Re: SO₂ Area Designation for Labadie Energy Center

Re: Comments on Ameren Missouri's Labadie Sulfur Reduction Project Quality Assurance Project Plan

Re: 2015 Monitoring Network Plan

Figure 2. Expected peak SO₂ concentration areas per DNR's modeling.

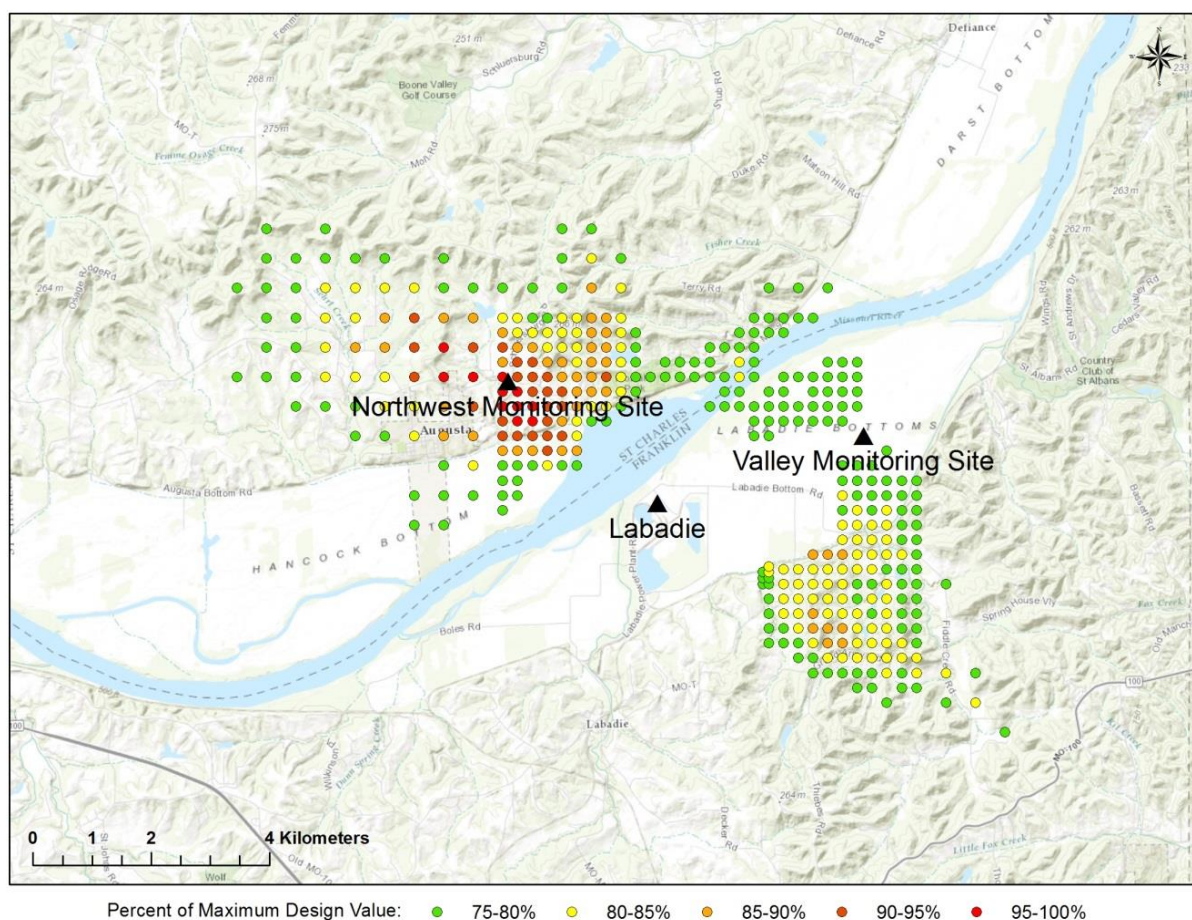
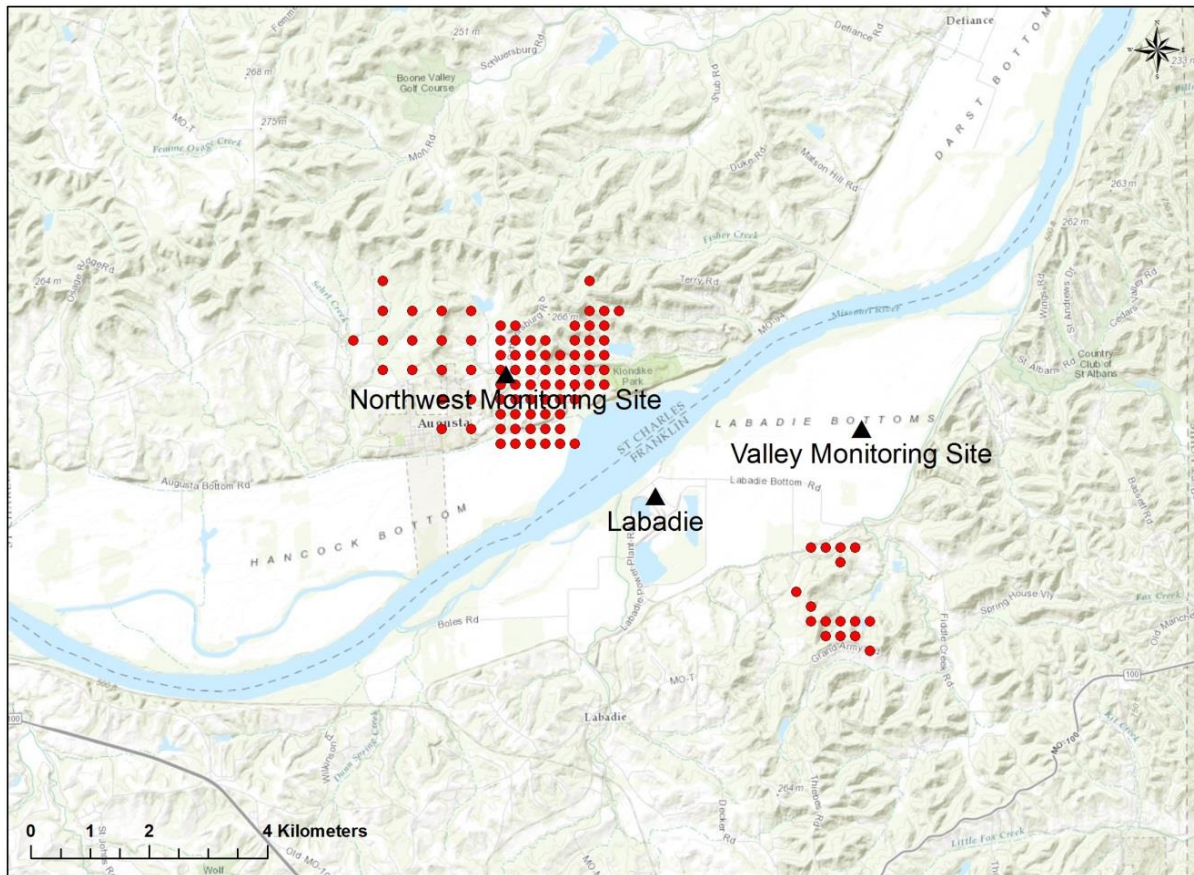
DNR's modeling, as illustrated by Figures 2 and 3, confirms that the Valley monitoring site is not located in an area where peak SO₂ concentrations are expected to occur. To the contrary, the Valley site is in an area where the modeled concentration is less than 75 percent of the maximum concentration predicted by DNR's model. DNR's modeling also confirms that there is an expected peak concentration area southeast of the plant with considerably higher modeled SO₂ design values than at the Valley monitoring site, yet with no monitor. DNR's model predicts NAAQS exceedances in this other area, but not at the Valley site.

Figure 4. Valley monitoring site (left) and KSUS (right) wind rose comparison.

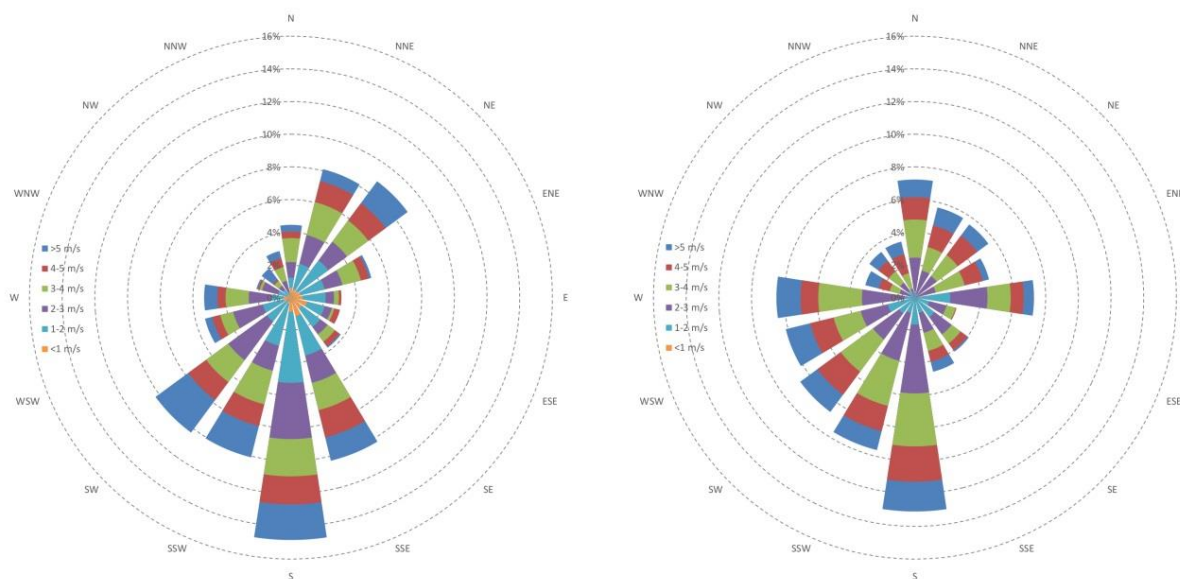
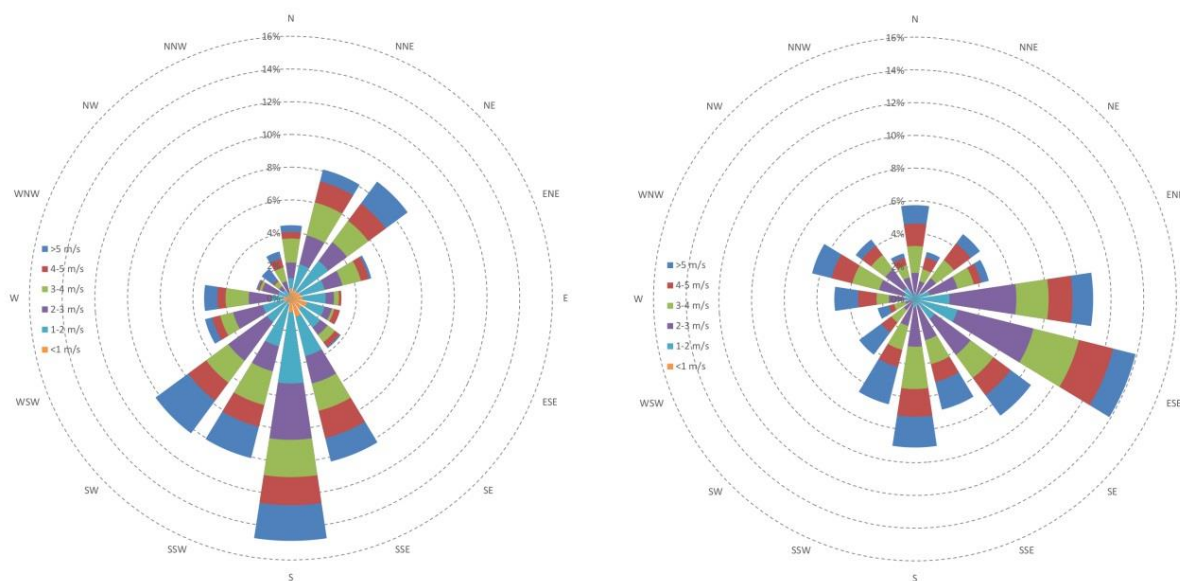
Figures 4 and 5 (see next page) show the wind rose for the Valley monitoring site compared to the wind roses for KSUS and KJEF, respectively, for the period April 22 – July 13, 2015. As illustrated by Figures 4 and 5, during the first few months the Valley meteorological monitoring station was in operation, the most frequent winds at both Labadie and KSUS were from the south, south-southwest, and southwest, whereas the most frequent winds at KJEF were from the east and east-southeast. Furthermore, the strongest winds at both Labadie and KSUS were generally from the predominant wind directions whereas the strongest winds at KJEF were from the south and south-southwest, orthogonal to the predominant wind directions.

Therefore, the preliminary meteorological data from the Labadie area suggest that the winds at Labadie may be more similar to the winds at KSUS than the winds at KJEF, which in turn suggests that KSUS surface meteorological data may be more representative of the area and more appropriate for modeling Labadie's emissions than KJEF data.

Figure 6. Expected peak SO₂ concentration areas per DNR's modeling using KSUS instead of KJEF surface meteorological data.

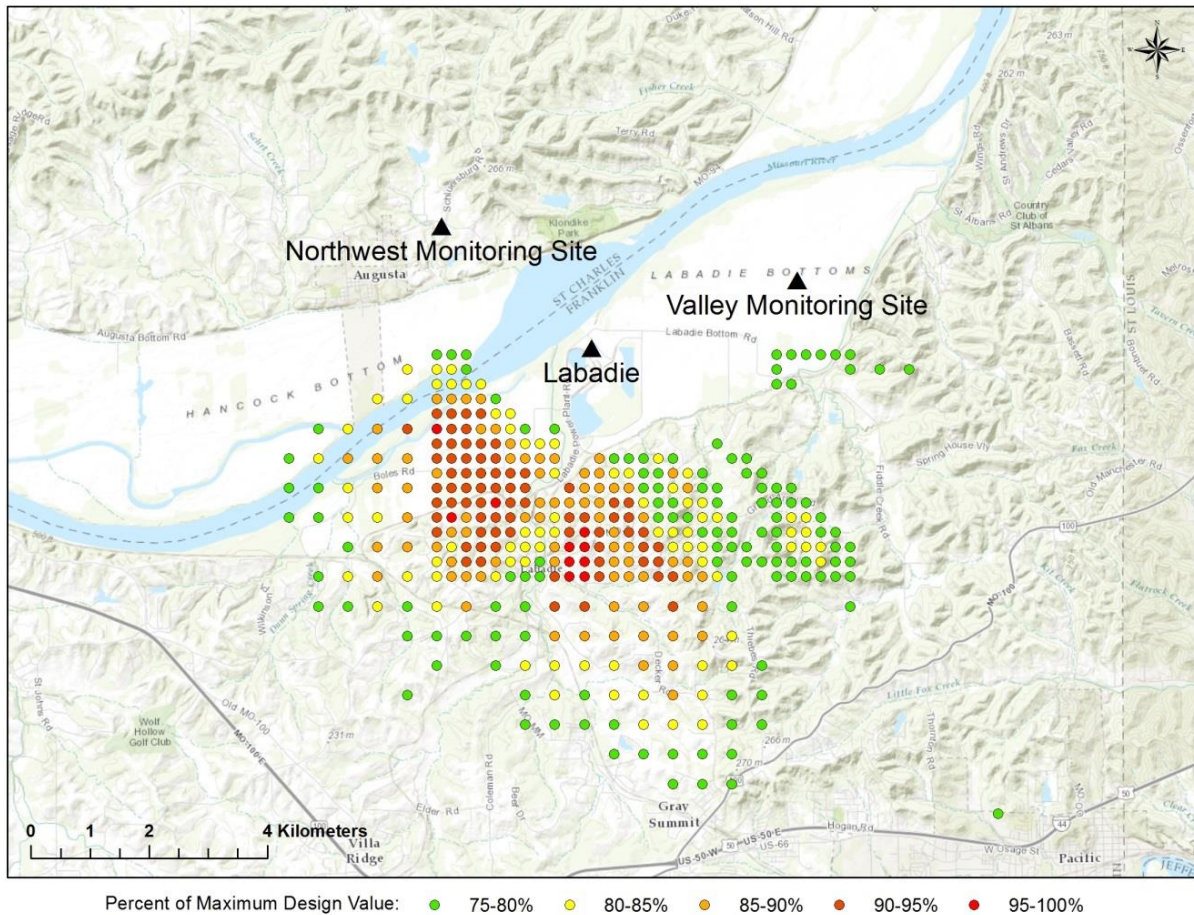
Figure 6 (see next page) shows peak concentration areas, demarcated by orange and red receptors, predicted by DNR's model when KSUS surface meteorological data is used instead of KJEF data. The results are striking; *if KSUS data is in fact more representative of the area than KJEF data, then neither the Valley monitoring site nor the Northwest monitoring site is located in an area where peak SO₂ concentrations are expected to occur and neither is appropriately sited for use in future NAAQS compliance evaluations.*

We recognize that the wind climatology data from the Valley meteorological monitoring site included in Appendix F of DNR's 2016 Area Boundary Recommendations is not yet quality assured and that, given the short-term nature of the data, it is by no means certain that the winds at Labadie will prove to be more similar to the winds at KSUS than at KJEF over the long term. However, this only demonstrates further why DNR should wait until EPA completes an area designation for Labadie before proposing new SO₂ monitoring sites near the plant. EPA must make a final area designation for the plant by July 2016.⁷ By that time, DNR will have over a year of on-site meteorological data from the Valley monitoring site and a second meteorological monitoring station at the nearby Osage Ridge monitoring site,⁸ which it can then use to model Labadie's emissions for monitor-siting purposes or to make a more definitive determination regarding which airport site has the most representative meteorological data and should be used in such modeling.
